AMERICAN FORK CITY
DEVELOPMENT REVIEW COMMITTEE AGENDA

a. Review and action on an application for a Preliminary Plan, known as Landon Court (East), located at approximately 1228 East 700 North, American Fork City, UT 84003. The Preliminary Plan will be for approximately 1.38 acres and will be in the R1-15000 Zone.

b. Review and action on an application for a Final Plat, known as Landon Court (East), located at approximately 1228 East 700 North, American Fork City, UT 84003. The Final Plat will be for approximately 1.38 acres and will be in the R1-15000 Zone.

DRC Plan Review Meetings

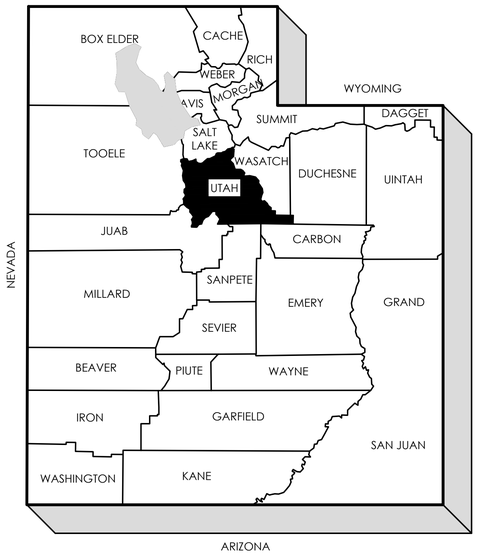
Address storm drain review comments

Pending review and confirmation from HOA that proposed 8" waterline presents no issues or concerns

C300

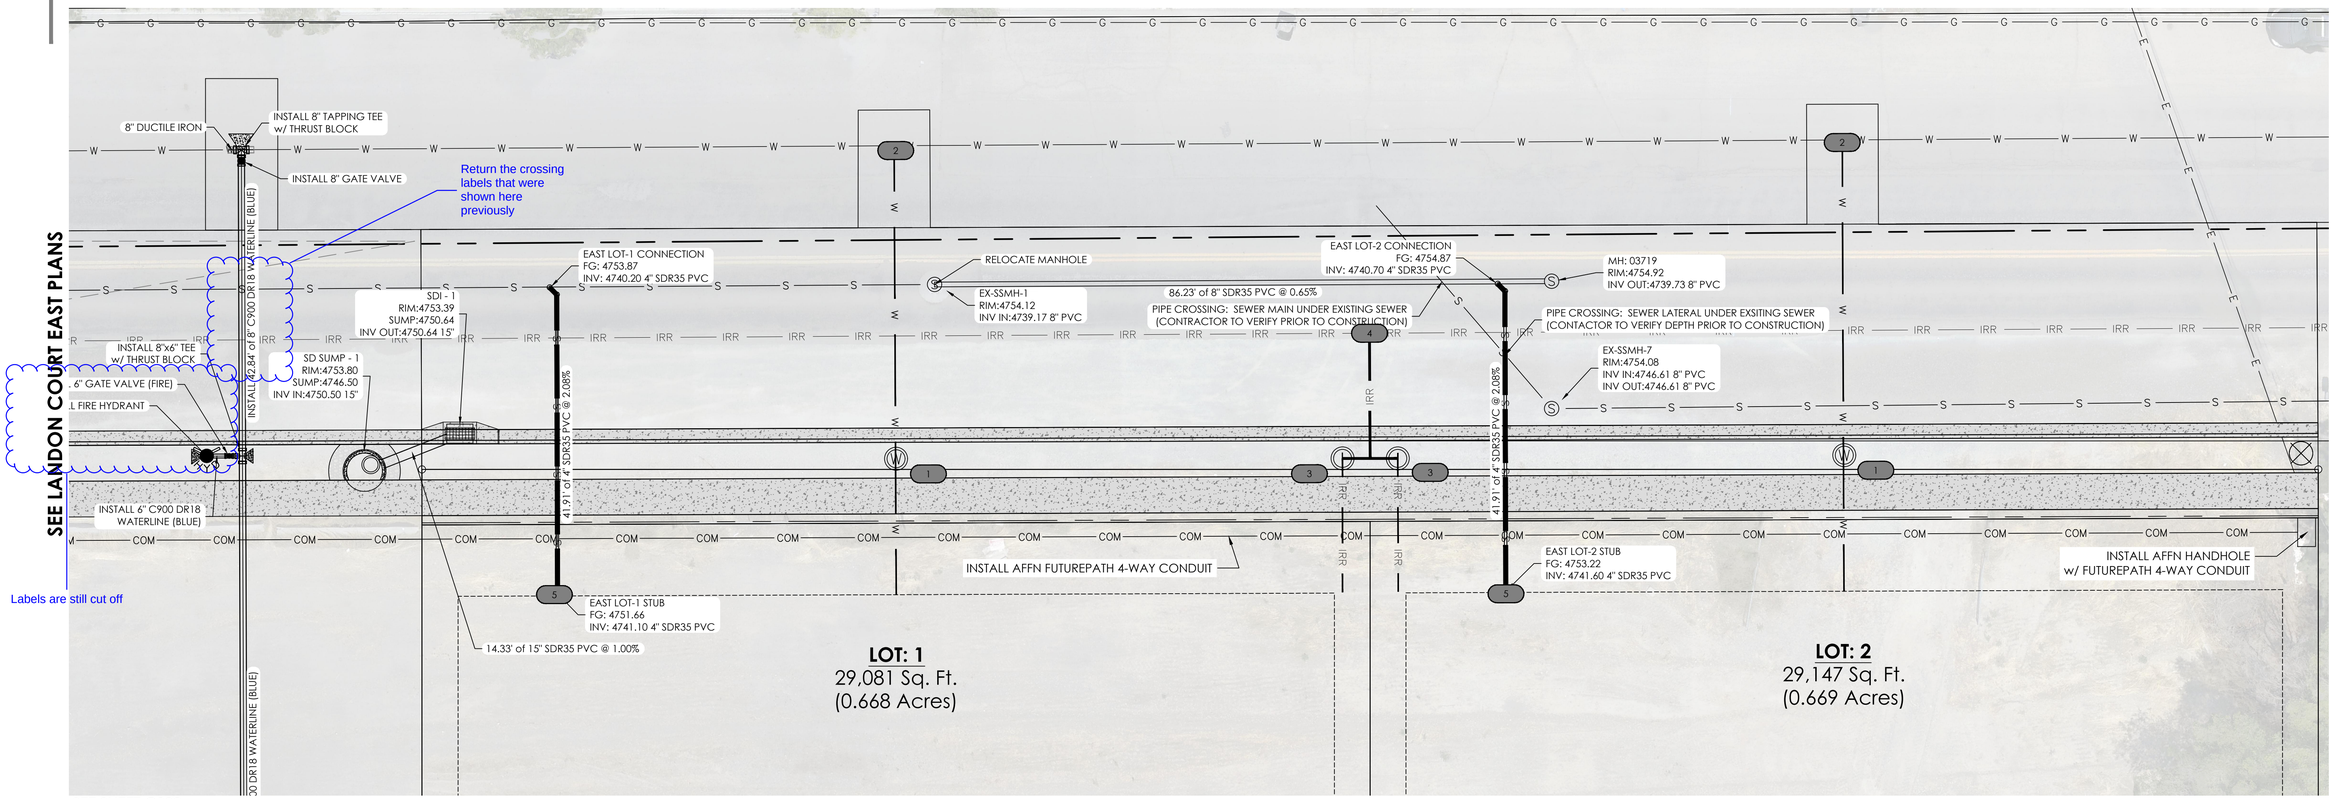
Labels are still cut off

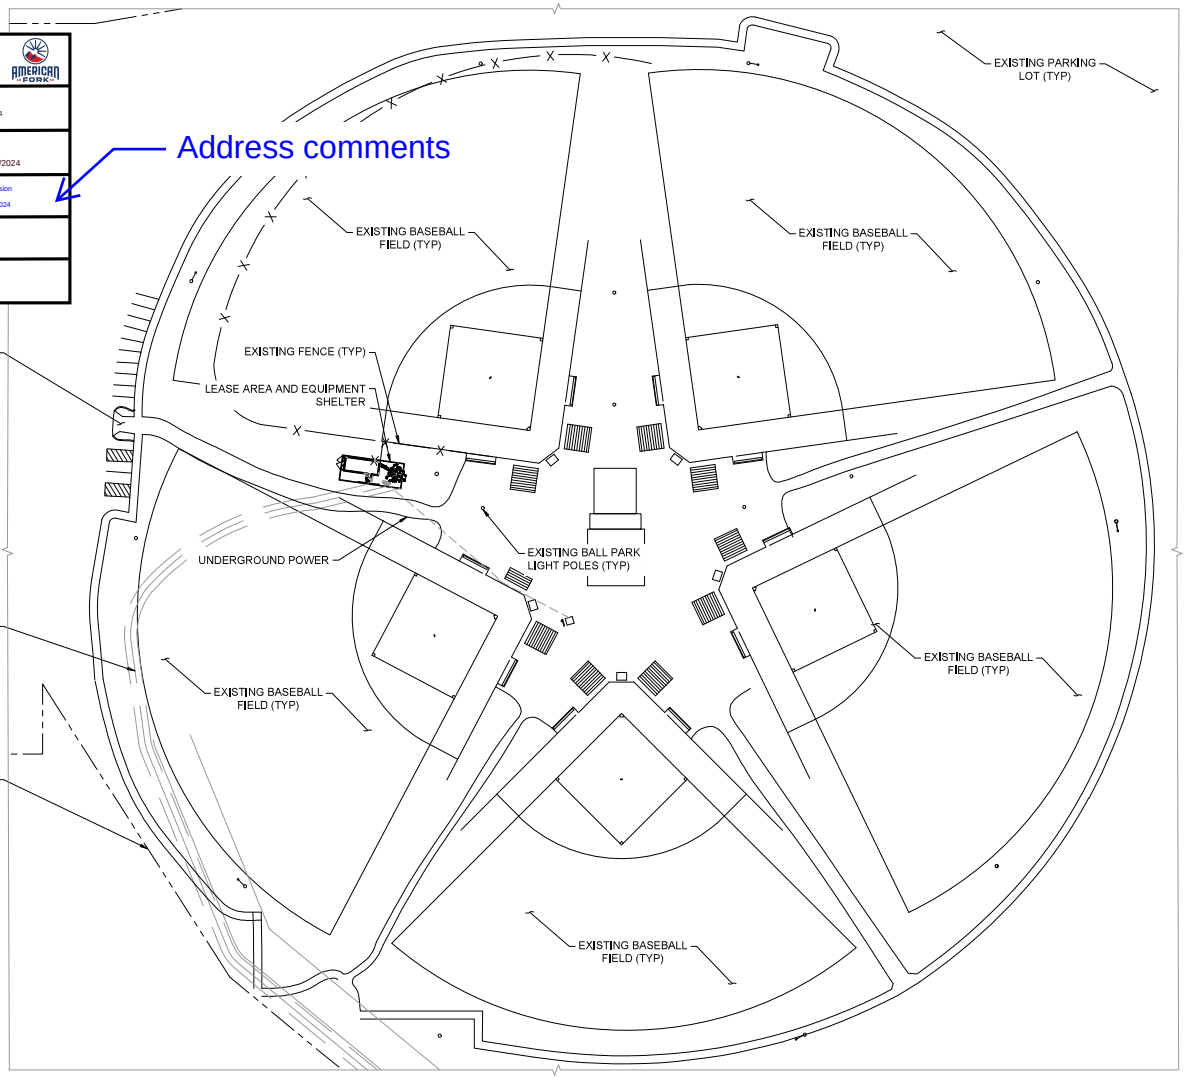
Address comments
